K18X001.00 FT2 Station Test Fail Report

FT2 Station ETE Yield Rate

TOP1: Full Range Speaker_Frequency Response – 8k Hz Check Fail-2

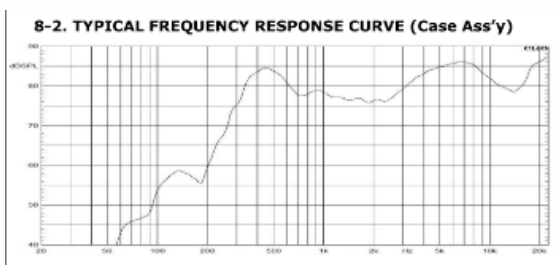
4. Check datasheet of full range speaker, PN: 352.00192.005LT, Des: SPEAKER 4+-0.6ohm 79+-3dB 8~15W GP

→ Check datasheet of full range: when case assembly have power = 85dB at frequency 8K Hz

5. Full Range Speaker_Frequency Response – 8k Hz CPK report:

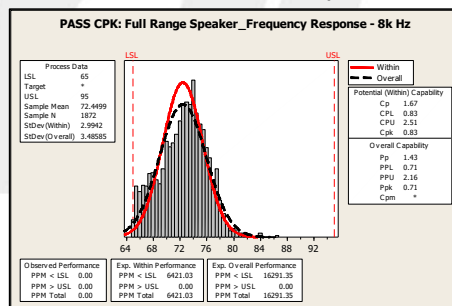
- Check CPK PASS and Fail report of Full Range Speaker_Frequency Response – 8k Hz:

For Pass CPK , CPK = 0.83. level C. Need RD/ TE/ PE/ ME/ Sound bar vendor improvement, average pass value : 72db is less 13 db than datasheet = 85db

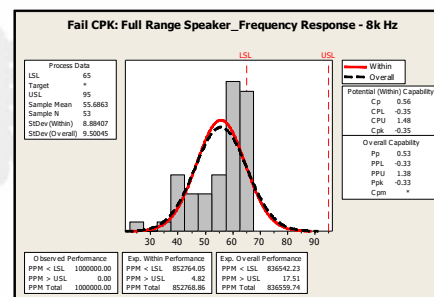
- Change other full range speaker (PN: 352.00192.005LT) can solve this issue but we can not confirm material issue or not
- Suggest change spec from (65, 95)dB to (54, 90)dB to improve this issue

For Fail CPK data , CPK = -0.35 . Fail value from 27 dB to 64.9db

Next step for 8KHz FR test:

1. According to cpk, the volume seems too low and need to change ALT volume table to increase SPL on FATP chamber.
2. The average value of 8KHz should be shifted to middle between LSL and USL as 80dBSPL.
3. Not allow FATP to change 8KHz FR test spec as 56~90dB[spec: 65~95dBSPL].
4. Next step will verify ALT volume table to test FW.

4. Woofer Speaker_Air Leakage Test_Pushing - 550 Hz CPK value

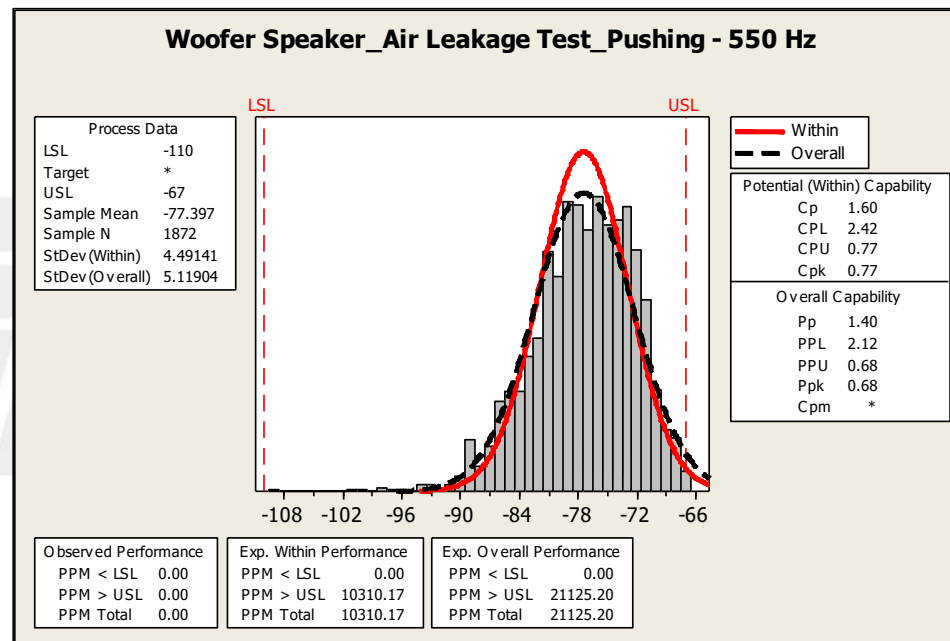
- Check CPK value of Woofer Speaker_Air Leakage Test_Pushing - 550 Hz

- CPK value = 0.77. level C. Need RD/ TE/ PE/ ME/ Sound bar vendor improvement, average pass value : -77.34db is higher than average of spec (-110, -67) = 11.16db
- Suggest change spec from (-110, -67)dB to (-99, -56)dB to improve this issue

Next step for air leakage test:

1. As the fail symptoms are pushing(little gap) and top cover not assembly well issues.
2. As before verified, power spectrum and 850Hz solution can screen these symptoms.
3. Not allow FATP to change spec -99~-56dB [spec: -110~-67dB] @550Hz.
